# Analysis of comments on D2.1

Editorial Staff 802.3an

# Introduction

## 55.11.7 Delay constraints

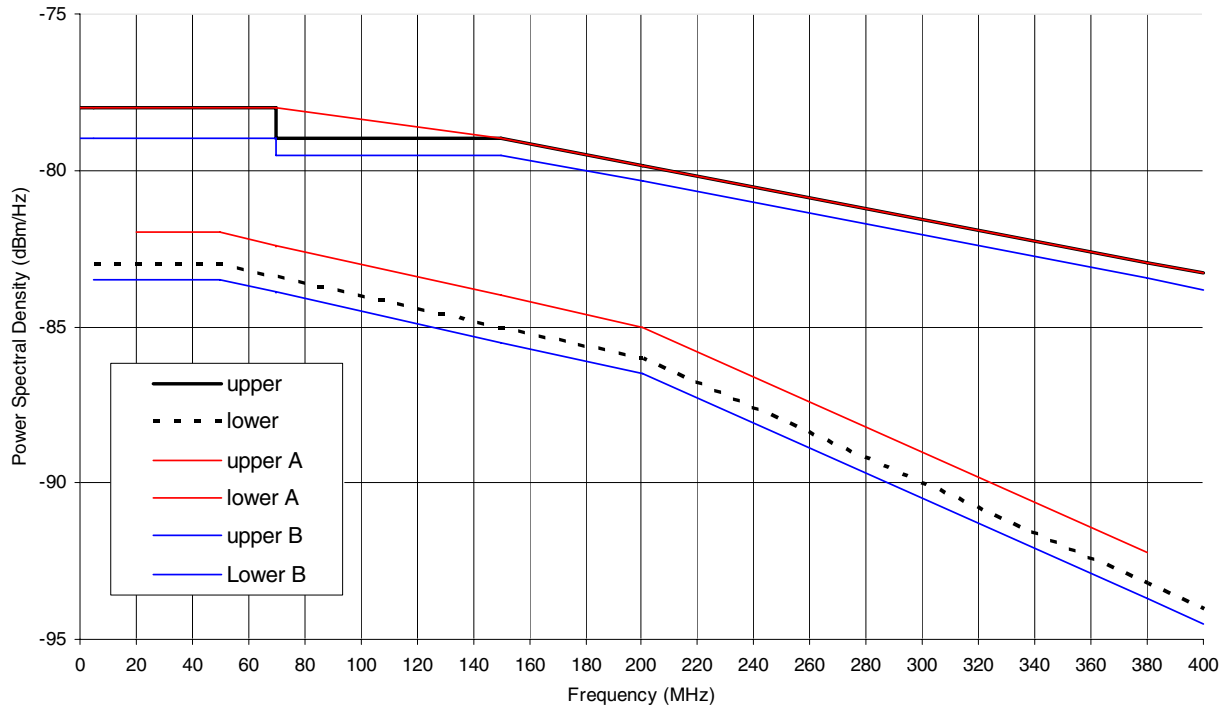
- Delay Constraints
  - Comments (10):
    - Draft 2.1 specifies a maximum latency of ~10 microsec
    - Shimon Mueller, Hugh Barrass, Pat Thaler, David Law, Geoff Thompson suggested reducing the max latency (~2.5 microsec)
    - Recommendation:
      - Task force to discuss and reduce the maximum latency

- See text on Delay Text slide

The sum of the transmit and receive data delays for an implementation of a 10GBASE-T transceiver shall not exceed 25,600 BT. Transmit data delay is measured from the input of a given unit of data at the XGMII interface to the presentation of the same unit of data by the PHY to the MDI interface. Receive data delay is measured from the input of a given unit of data at the MDI interface to the presentation of the same unit of data by the PHY to the XGMII interface. The time required to insert or process any necessary overhead or stuff octets must be included as part of the data delay incurred by the 10GBASE-T PHY.

Round-trip delay through a link consisting of two compliant PHYs and any 55.7 compliant media connecting them shall not exceed 51,200 BT plus the media delay (as computed using equation 44-1 or Table 44-3).
